INDIAN SPRINGS SUBDIVISION

BOZRAH, CONNECTICUT

ENVIRONMENTAL REVIEW TEAM REPORT

April 1997

Figure 2

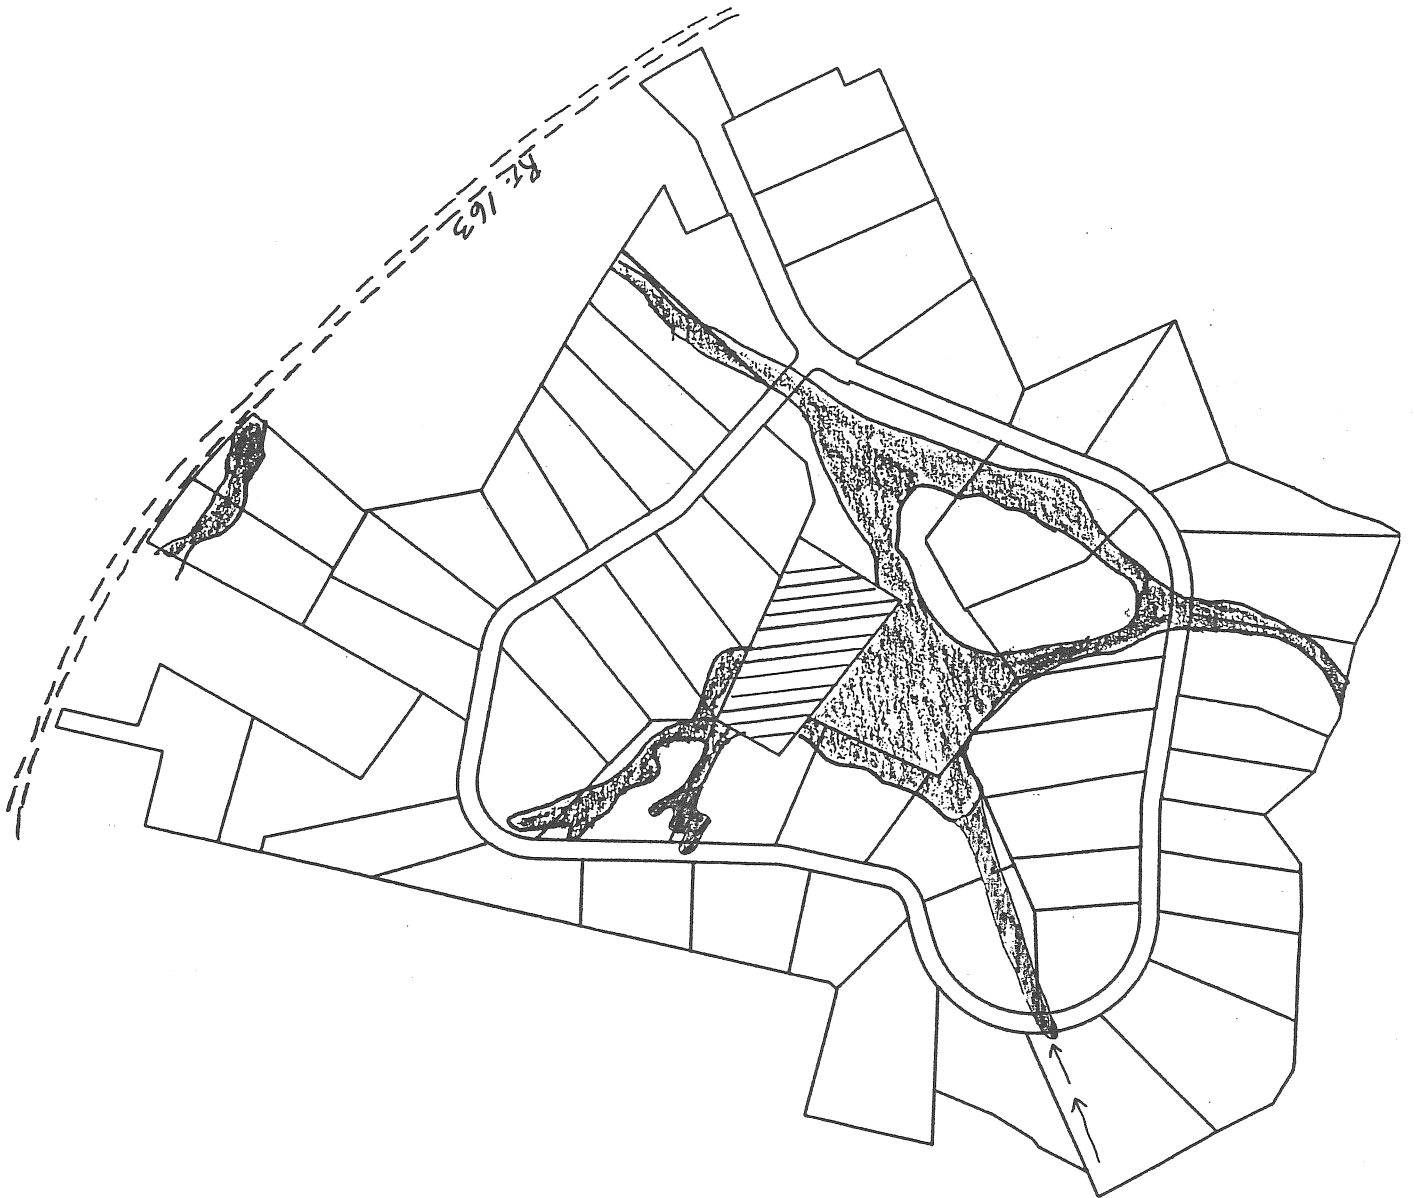
If this is not possible, relocation of the driveway to road station 24+00 so that the wetland crossing may be located off of what is now the northerly boundary of lot 49 would be preferred for two reasons: 1) a small, unimproved wetland crossing already exists at this location and, 2) this wetland area is narrower and of lower quality than the proposed crossing area.

- 2) If feasible, it is recommended to "slide" the "T"-junction at road station 9+50 to the northwest as far as possible. This would result in a wetland crossing in an area that may be narrower and would definitely be of lower quality than the currently proposed crossing (the value of this wetland appears to decrease as you move up-gradient in the wetland corridor to the northwest).

- 3) If feasible, it is recommended that the road tangent from 10+00 to 17+00 be moved as far as possible to the northeast to avoid indirect buffer impacts that are currently proposed for high quality wetlands located within 20 feet of road station 17+00.

- 4) Alternative locations for the stormwater outlet and level-lip spreader located on lot 41 should be investigated. The additional wetland mapping subsequent to the 1989 ERT report now has this structure located directly in a wetland. In general, this and all other stormwater outlets that are in or near wetland areas should be located as far away from wetlands as possible, given proper ground conditions, to allow as much treatment of storm water prior to wetland entry.

- Wetlands occupy large portions of lots 39, 40, 41, 50 and 51. The option to not develop these lots or to decrease the number of lots developed in these areas should be considered in order to maintain the ecological integrity of the wetlands. If lots 50 and 51 are to remain developed a shared driveway with a pull out is recommended.

The proposed open space is located in the center of the proposed subdivision adjacent to the proposed roads and the mineral springs town property. It represents about ten percent of the total subdivision area which meets the requirements of the subdivision regulations. If the open space will not be owned by the Town, then the right-of-way for access to the mineral springs town property should be indicated, most likely along the existing access driveway and the edge of the open space and lot 34.

The driveway onto Route 163 for proposed lot 54 will have a difficult site line and possibly could be combined with driveways serving lots 10 or 11.
